Building Permit Application

Permit No.: B15003051

From: Oswald, Hank
Sent: Friday, July 24, 2015 8:19 AM
To: 'dwhite@thompsongas.com'
Subject: B15003051 and B15003053

Subject: Project name Woodbine Crossing Lot # 11
Project site address 728 Woodbine Crossing Road
Permit # B15003051 SDP # _____
Other information pertinent to this project _____

REVISED

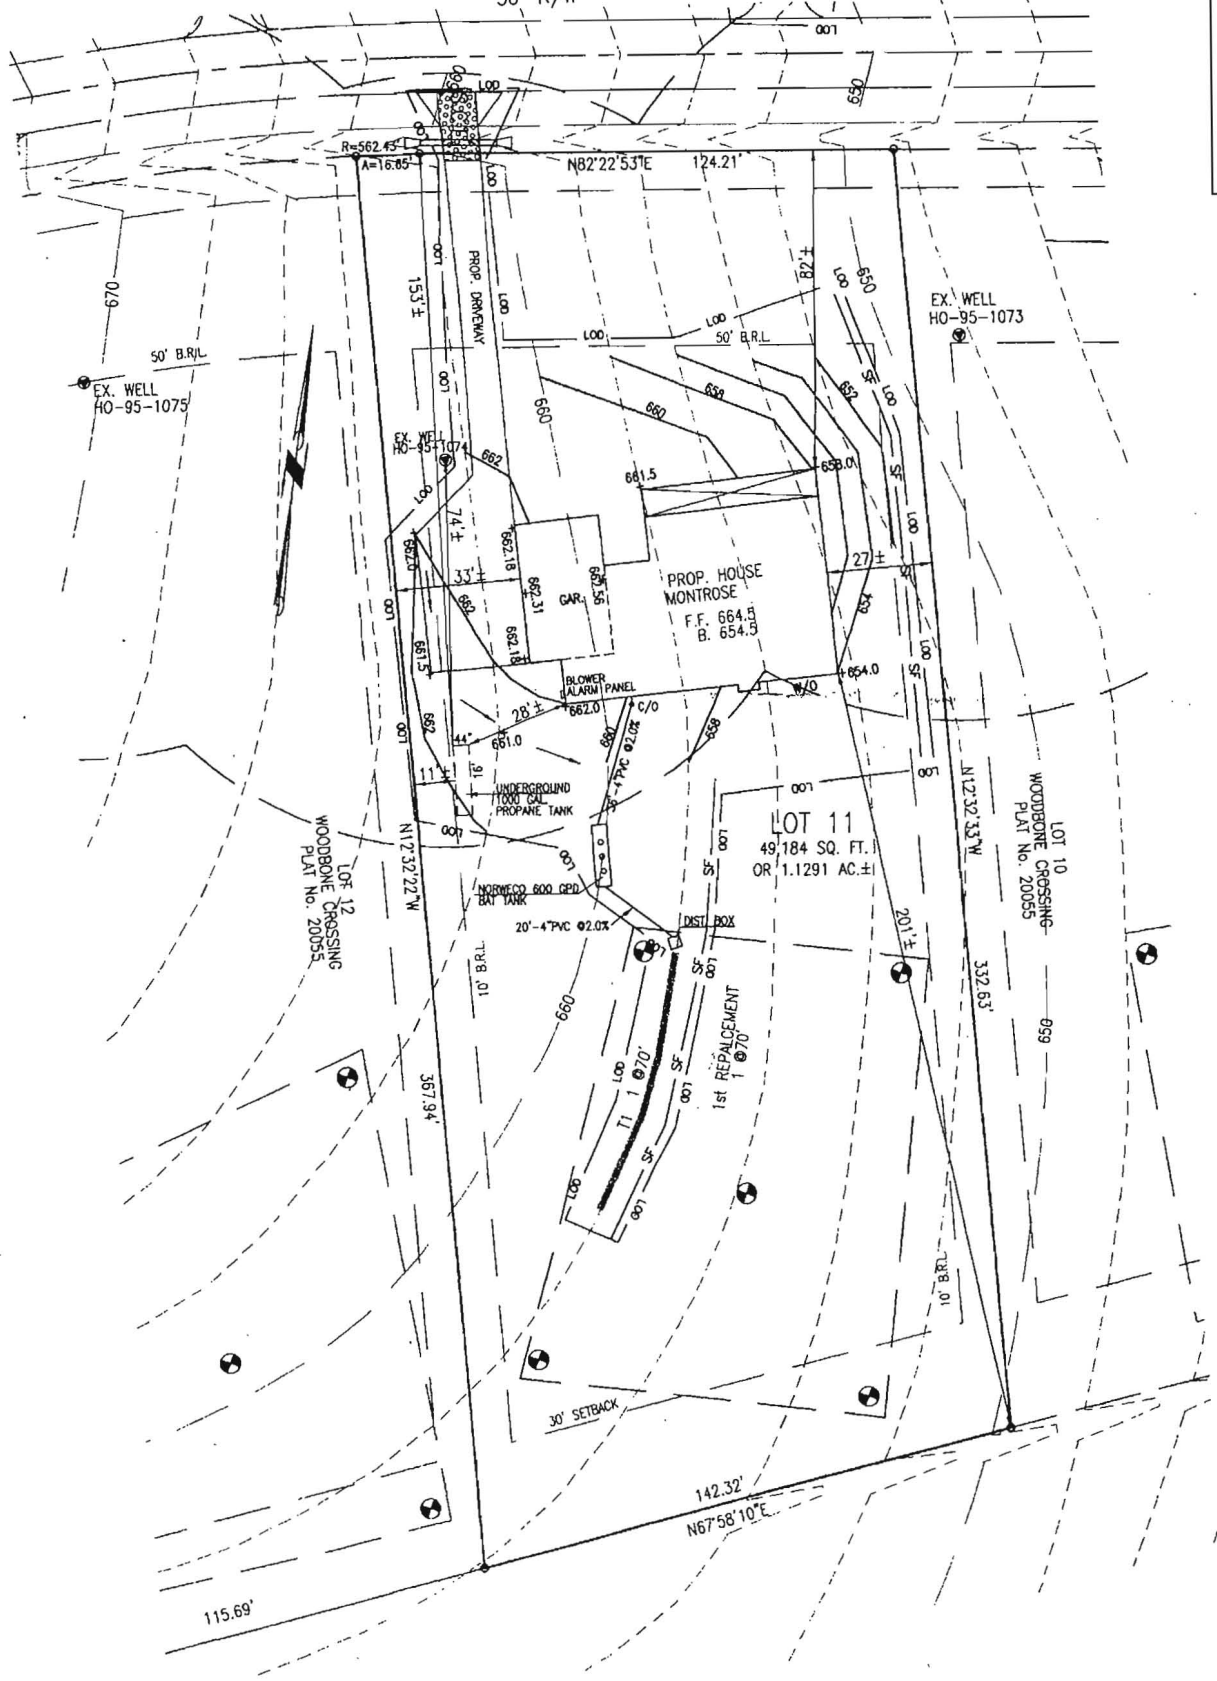
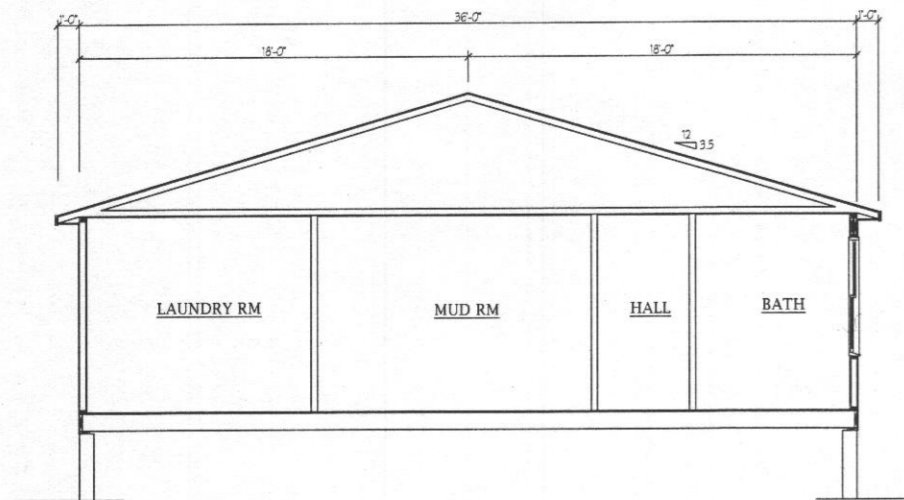
Upon review of the building permits noted in the subject heading, the site plans were submitted incorrectly/mismatched. Application for lot 11 has lot 13's site plan and vice versa.

Comments: Revised plot to reflect correct lot
